Flight Procedures Cover Page	Task Action: FLIGHT CHECK	Task Type: Segment	Estimated Chart Date: 11/30/2023	APWS Task ID: 7B3C10E2F5EC4973AF23250049A440FB	APWS Project ID: F6D287F6096240EB97EB407CF1F316E8
Procedure: T242 BRW VDME, AK TO TKA VDME, AK		Enroute: YES	Specialist: Gibson, Taylor		Agreement Number:
Airport ID:			Airport City:		State:
Facility ID:	Facility Type:	Flight Inspection Remark Type: New FC Slot

7/7/2023: THIS IS AN UPDATED COPY OF THE FORM DEVELOPED ON 9/1/2022.

08/31/2023: THIS IS AN UPDATED COPY OF THE FORM DEVELOPED ON 07/07/2023.

10/11/23: THIS IS A CORRECTED COPY OF THE FORM APPROVED ON 7/7/2023.

8260-16 WEGNO TO HUMUB:

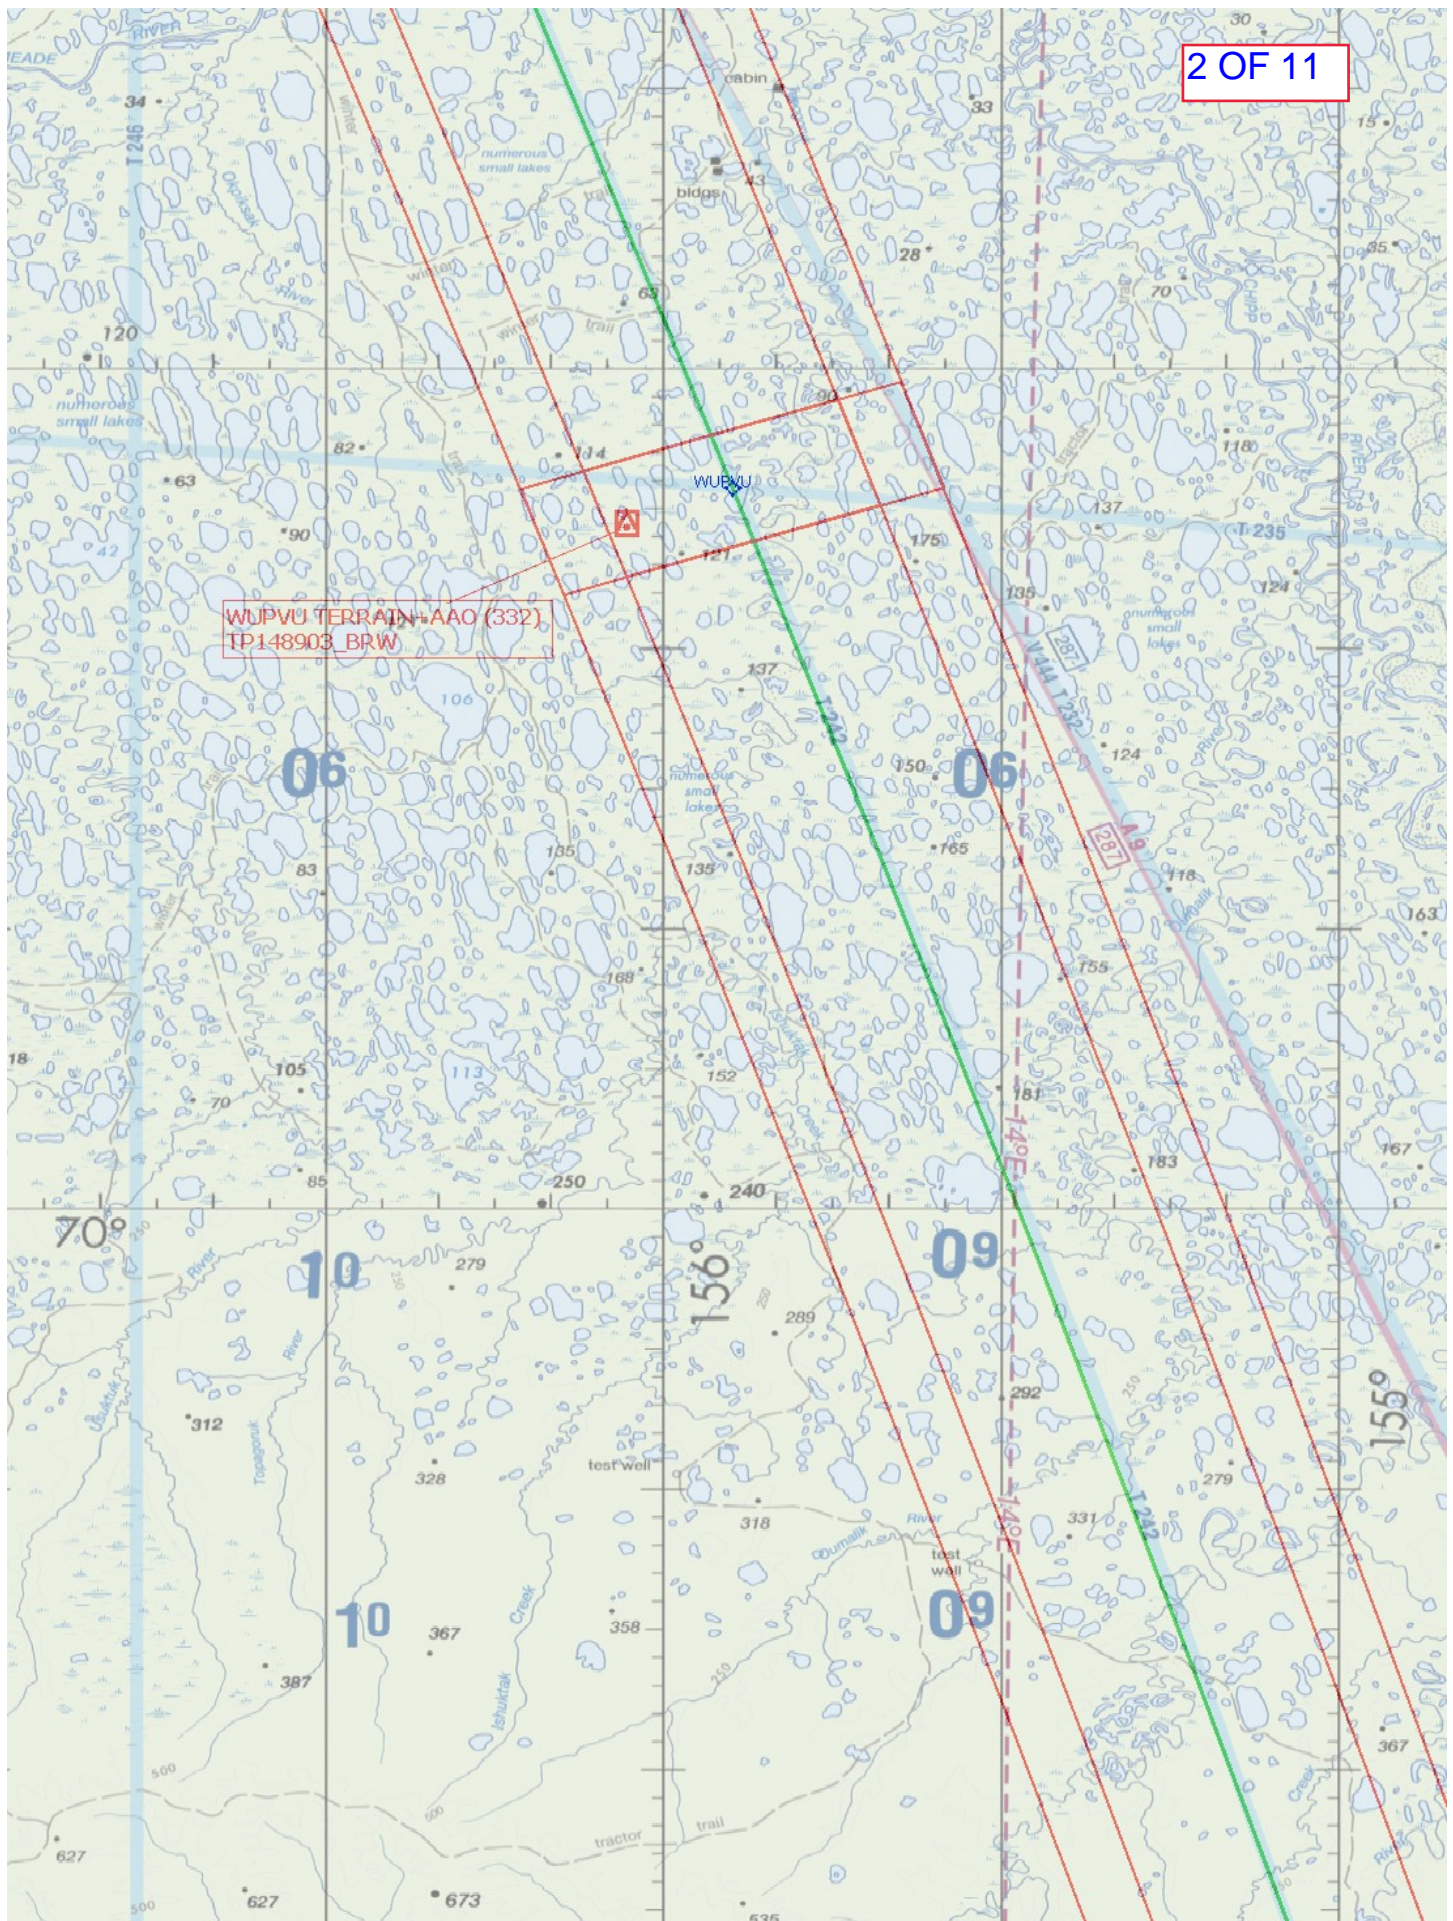
1) GNSS MEA CHANGED FROM 4200 TO 4600 - MATCH OVERLYING T381

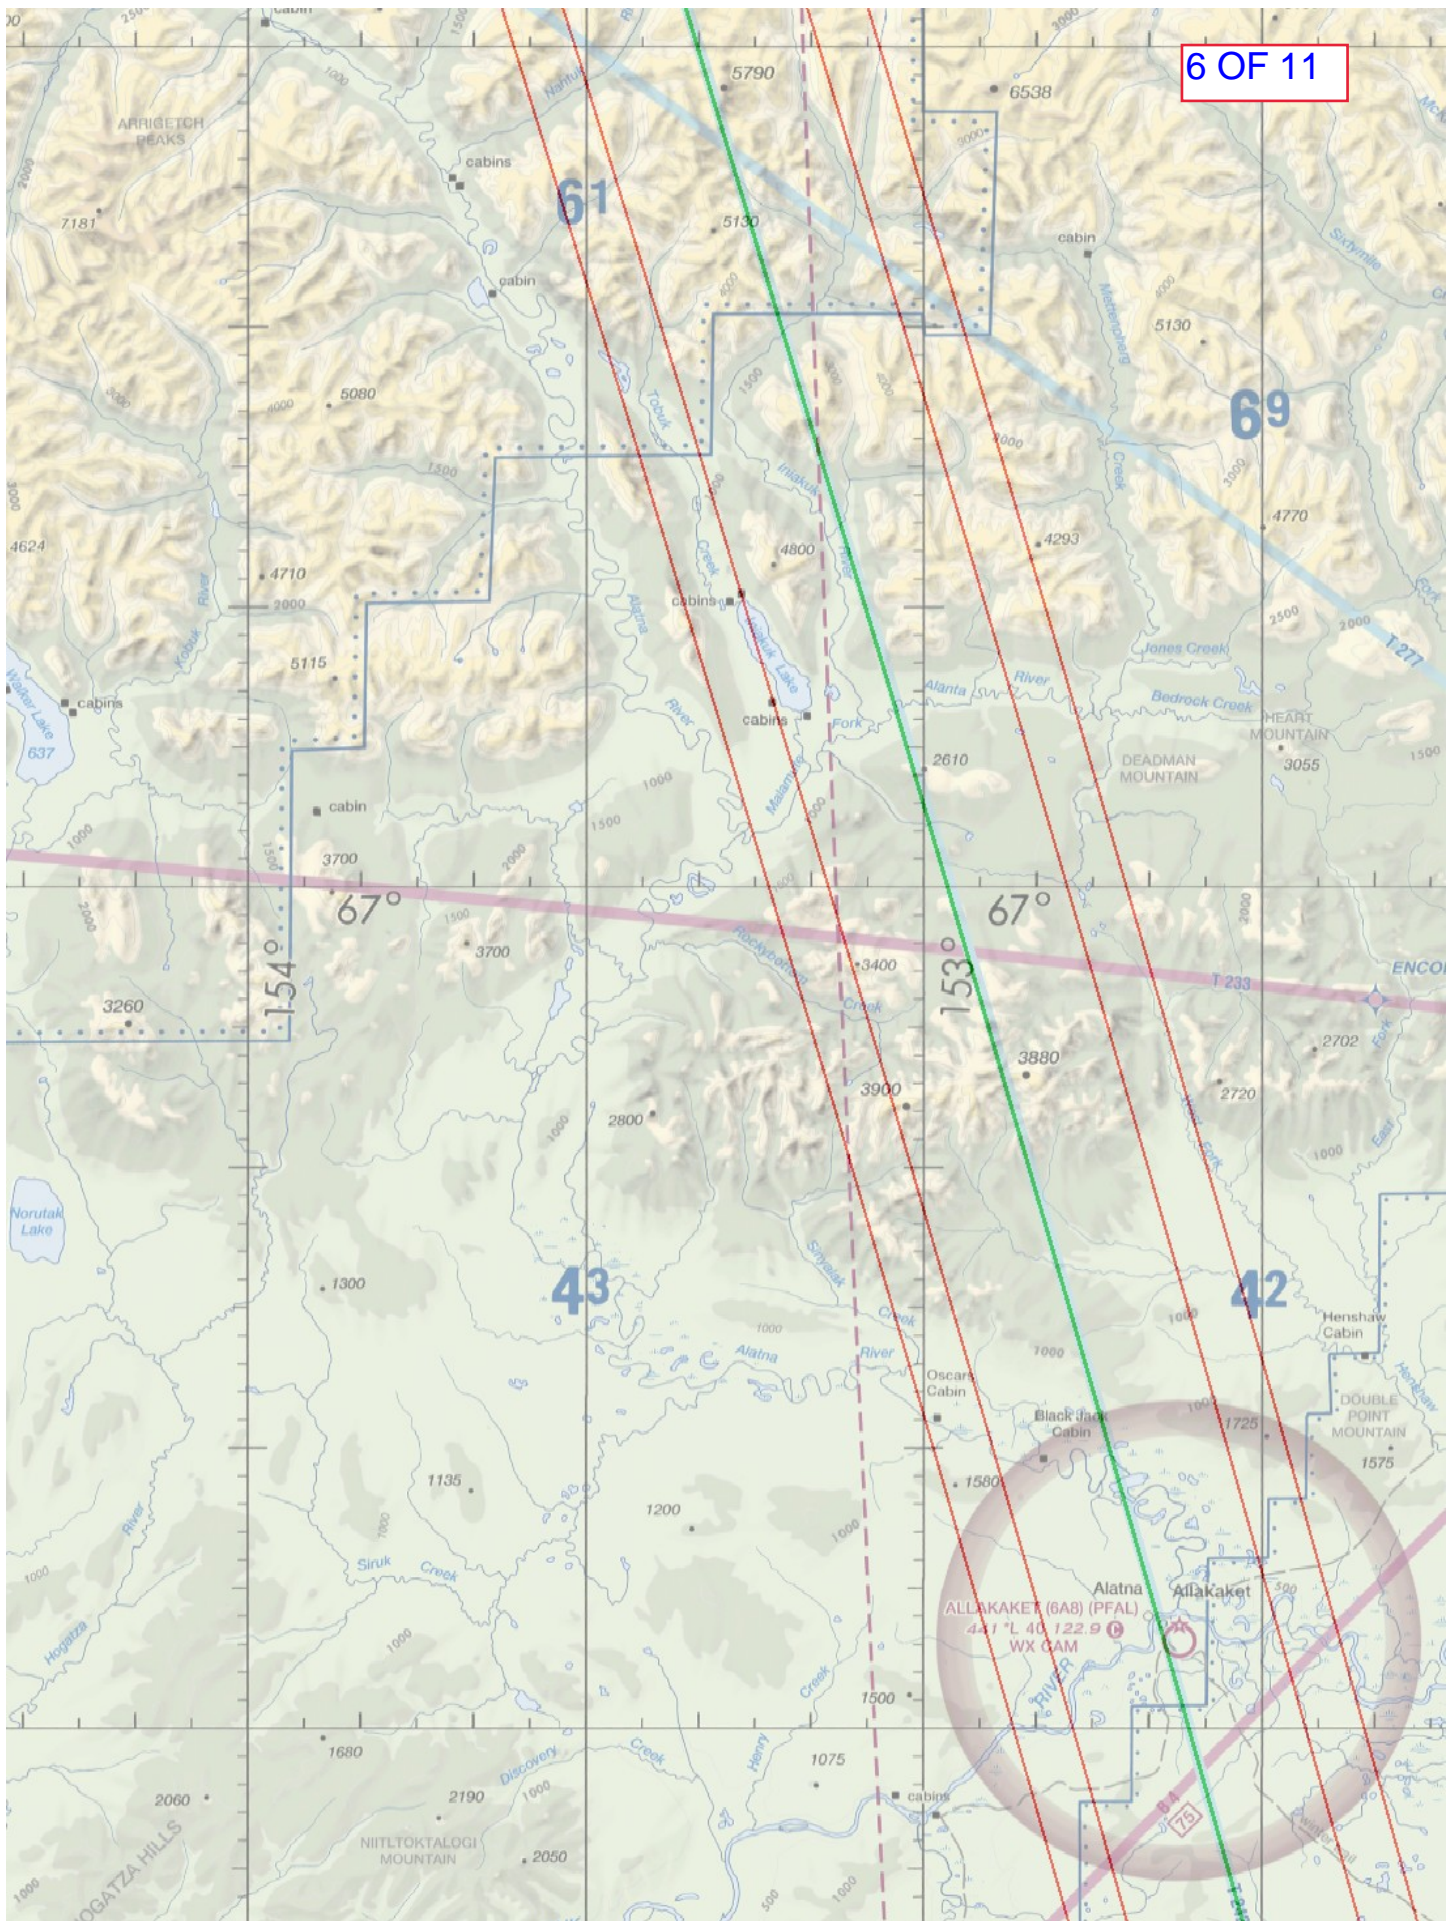
FLIGHT INSPECTOR REMARKS: Comms lost between LACIL and KUTDE, recommend 13500' for MEA and MRA.							
IN-FLIGHT OBSTACLE REPORT							
OBSTRUCTION ID #:	COORDINATES OR LOCATION:		GNSS ALTITUDE (MSL):		BAROMETRIC ALTITUDE (MSL):		HEIGHT ABOVE GROUND LEVEL:

1) ADDED MRA 13500, MEA 13500 - PER FLIGHT CHECK REPORT.
